Draft 100G SR4 TDP Update

John Petrilla: Avago Technologies
December 2013

Presentation Summary

- Present update of TDP setup and requirements for 100G 100m MMF Tx
- Present limitations of TDP metric for 100G 100m MMF
- Present alternative metric

100G 100m SR4: Transition time & RIN₁₂OMA tradeoff set TP2 contours (1)

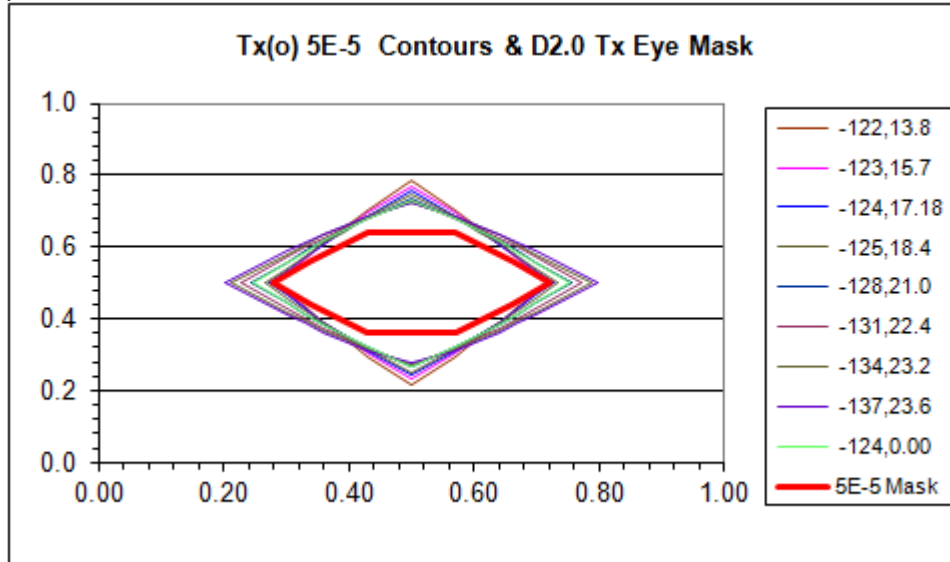
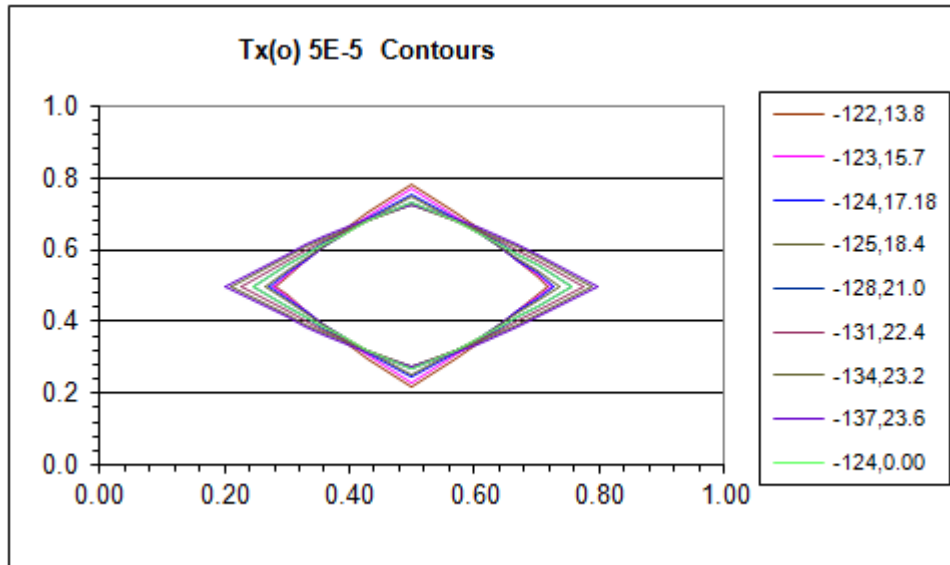
- The top chart shows 5E-5 contours of the Tx output (TP2) for the transition time and RIN₁₂OMA combinations providing zero link margin used in an earlier page. Here a Gaussian response is assumed, consistent with the assumptions in the link model.

- **The currently defined (draft 2.0) Tx eye mask is included in the bottom chart. It should be adjusted so that otherwise compliant transmitters are not rejected.**

100G 100m SR4: A metric to replace TDP 1 of 3

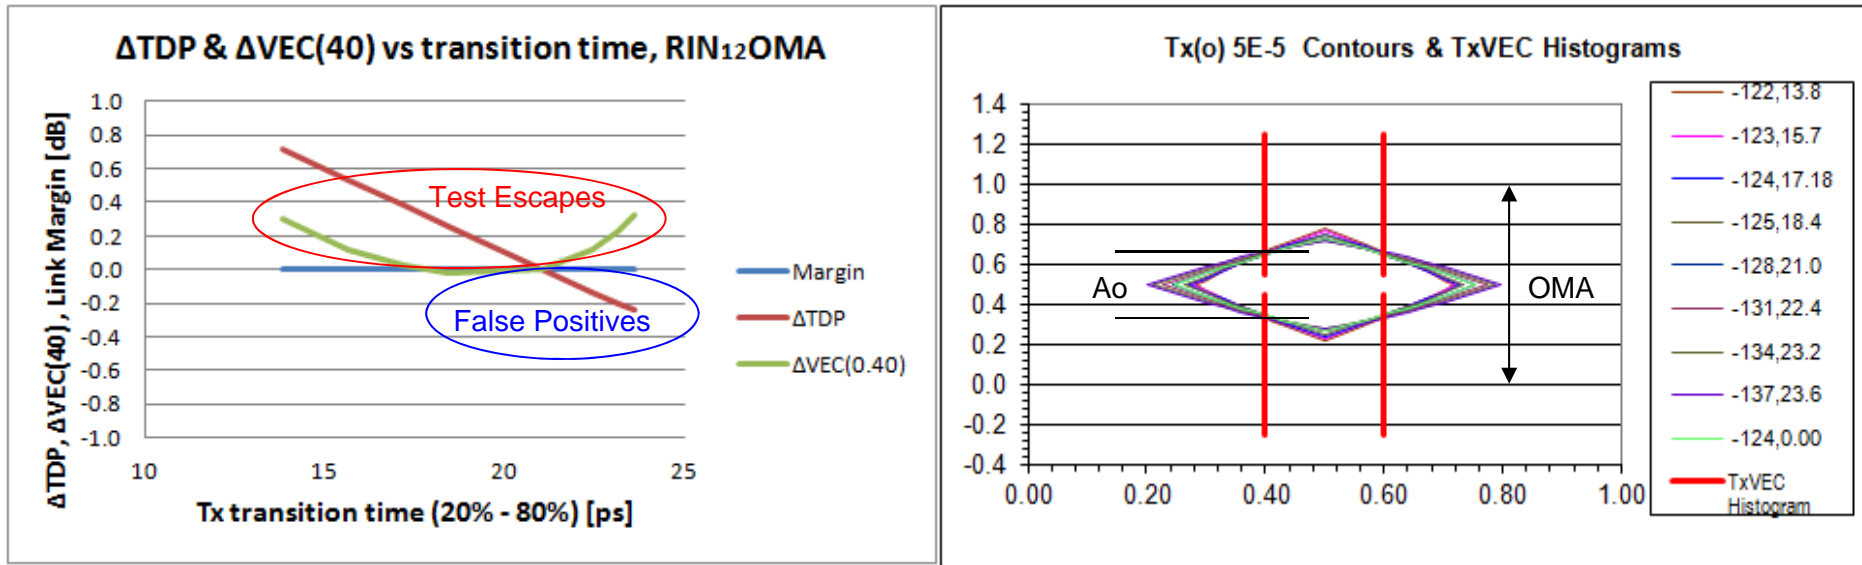
- The chart on the left indicates that a TxVEC metric, where $TxVEC = 10\log_{10}(OMA/Ao)$, can offer a better balance of test-escapes versus false-positives than a TDP metric. Here histograms are taken at ± 0.10 UI. Ao is the vertical eye height between 5E-5 points on the histogram tails. OMA is the signal amplitude measured with the OMA measurement method.

- The $\DeltaVEC(0.40)$ line is based on deviation from TxVEC calculated for the Tx baseline condition of a 21 ps Tx transition time and a RIN₁₂OMA of -128 dB/Hz. For this baseline condition TxVEC = 5.12 dB and based on this condition a **TxVEC max = 5.1 dB is recommended.**

- Note that there is no need for a reference transmitter for the TxVEC measurement. With the inability of TDP to predict link margin shown above, the use of a non-ideal Ref Tx to calibrate the Sensitivity of the Ref Rx is suspect.

- Based on the new metric TxVEC, in Draft 2.0 replace
 - in Table 95-6, Transmitter and dispersion penalty (TDP), each lane (max) = 5 dB
with Transmitter vertical eye closure, each lane (max) = 5.1 dB
 - in Table 95-6, Launch power in OMA minus TDP (min) = -8 dB
with Launch power in OMA minus TxVEC (min) = -8.1 dB
 - in Table 95-6, footnote b, Even if the TDP < 0.9 dB, the OMA (min) must exceed this value.
with Even if the TxVEC < 0.9 dB, the OMA (min) must exceed this value.
 - in Table 95-8, Power budget (for max TDP) = 8.2 dB
with Power budget (for max TxVEC) = 8.2 dB
 - in Table 95-8, Allocation for penalties (for max TDP) = 6.3 dB
with Allocation for penalties (for max TxVEC) = 6.3 dB

100G 100m SR4: Transition time & RIN₁₂OMA tradeoff set TP3 contours (1)

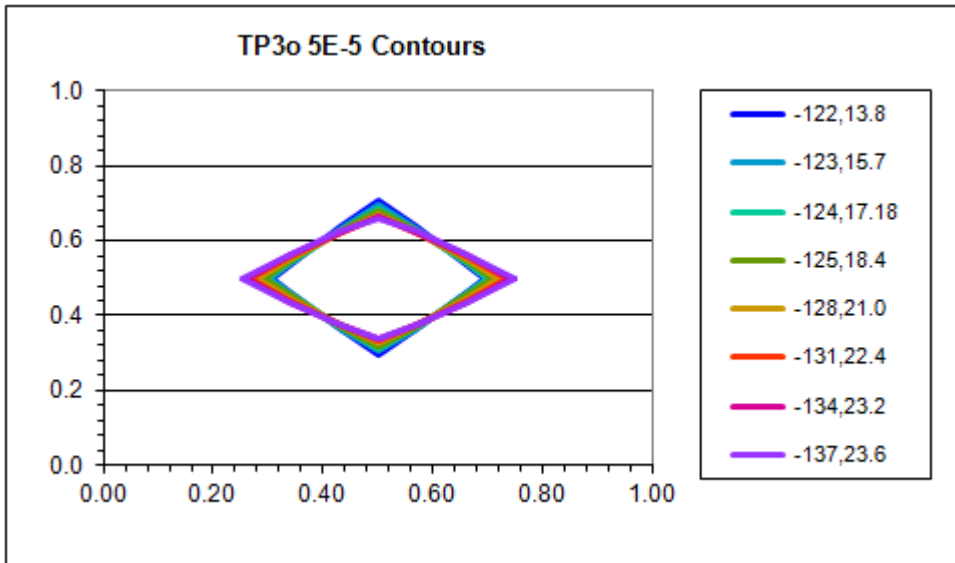
- The top chart shows 5E-5 contours of the fiber output (TP3) for the transition time and RIN₁₂OMA combinations providing zero link margin used in an earlier page.
- The currently defined (draft 2.0) SRS eye mask is included for reference in the bottom chart. While it captures one of several worst case TP3 eyes, some adjustment may be appropriate to accommodate more of the worst case contour set.

100G 100m SR4: Transition time & RIN₁₂OMA tradeoff set TP2 contours (2)

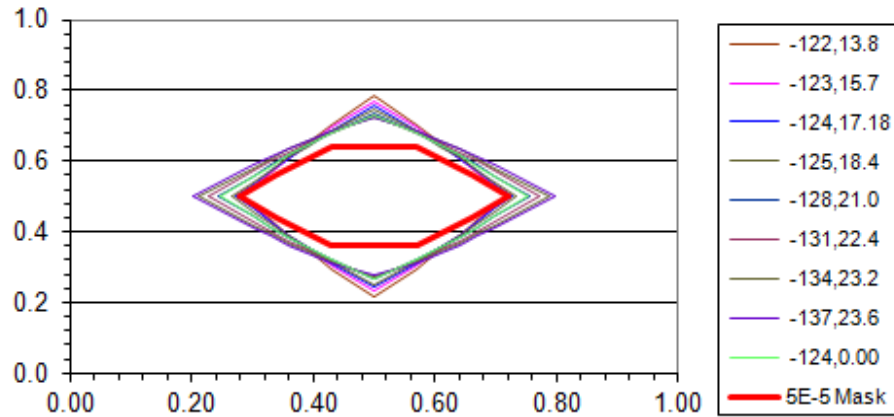
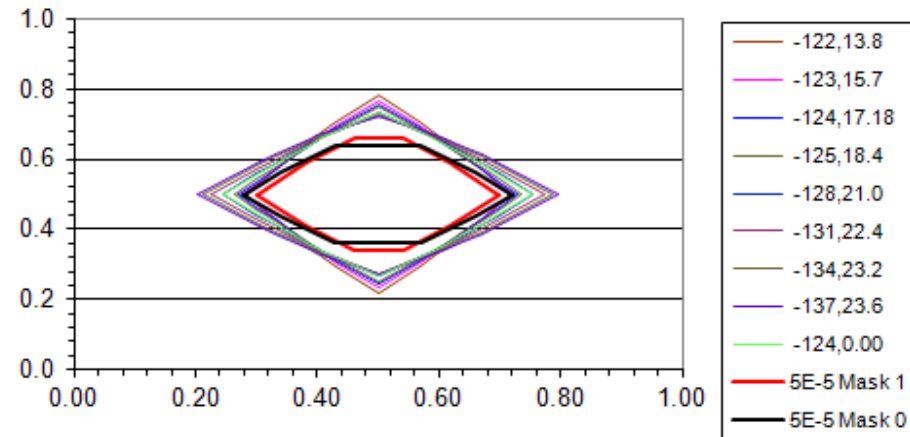
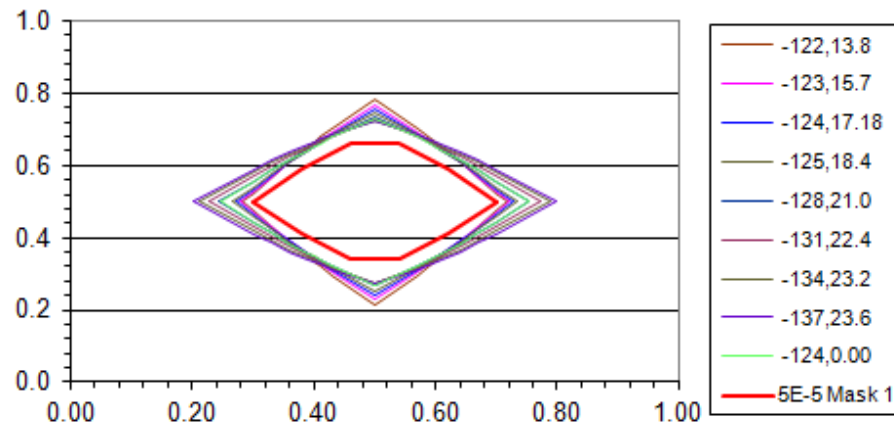
- All charts show a set of worst case Tx output 5E-5 contours.
- The currently defined (draft 2.0) Tx eye mask is shown in the top right chart with the set of 5E-5 contours.
- The proposed Tx eye mask (5E-5 Mask 1) is shown in the bottom left chart with the set of 5E-5 contours.
- The proposed Tx eye mask is compared with the existing Tx eye mask in the top right chart.
- Tx Eye Mask Coordinates: X1, X2, X3, Y1, Y2, Y3

Current: 0.28, 0.34, 0.43, 0.36, 0.44, 0.4

Proposed: 0.3, 0.38, 0.46, 0.34, 0.41, 0.4

100G 100m SR4: Transition time & RIN₁₂OMA tradeoff set TP3 contours (2)

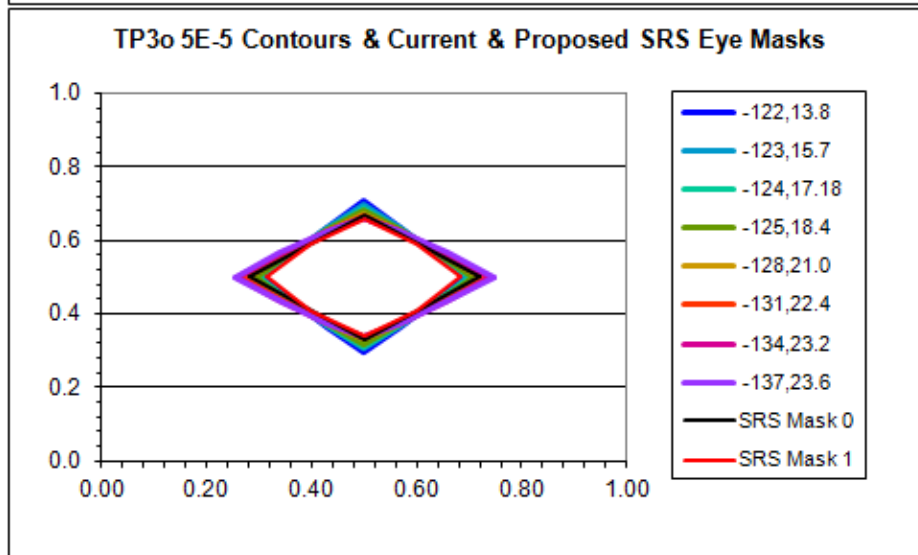
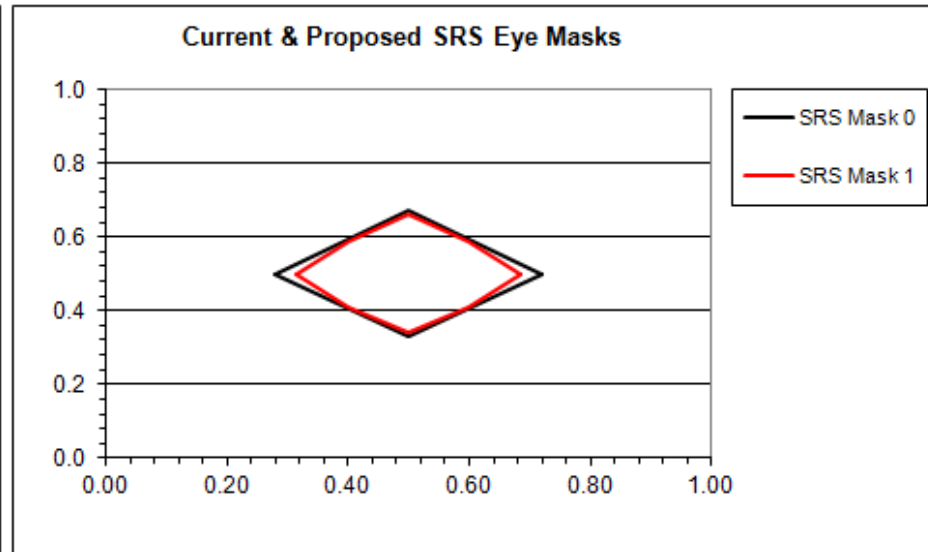
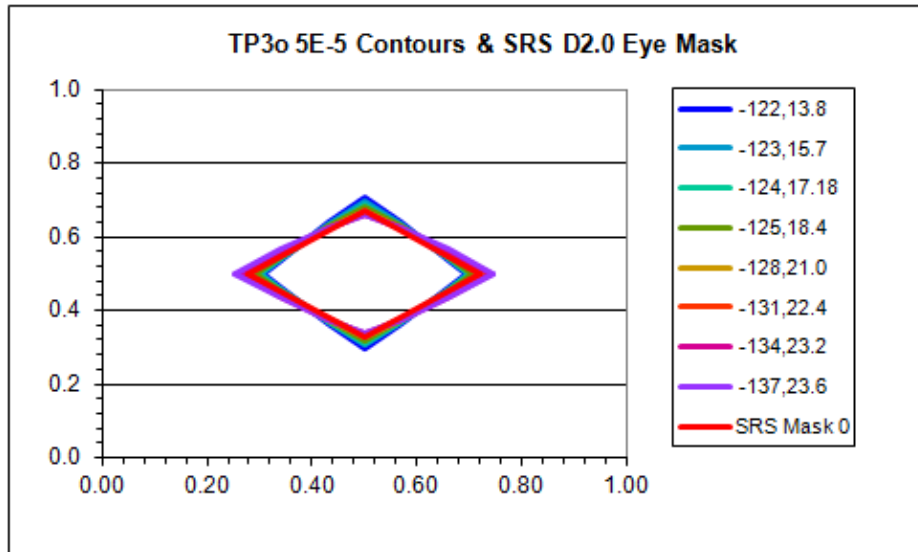
- The top left chart shows 5E-5 contours of the fiber output (TP3) for the transition time and RIN₁₂OMA combinations providing zero link margin used in an earlier page and the current SRS mask (SRS Mask 0)
- The bottom left chart repeats the above and also shows the proposed SRS mask (SRS Mask 1).
- The top right chart provides a comparison of the current and proposed SRS masks.
- SRS Eye Mask Coordinates: X1, X2, X3, Y1, Y2, Y3

Current: 0.28, 0.5, 0.5, 0.33, 0.33, 0.4

Proposed: 0.315, 0.4, 0.5, 0.34, 0.41, 0.4
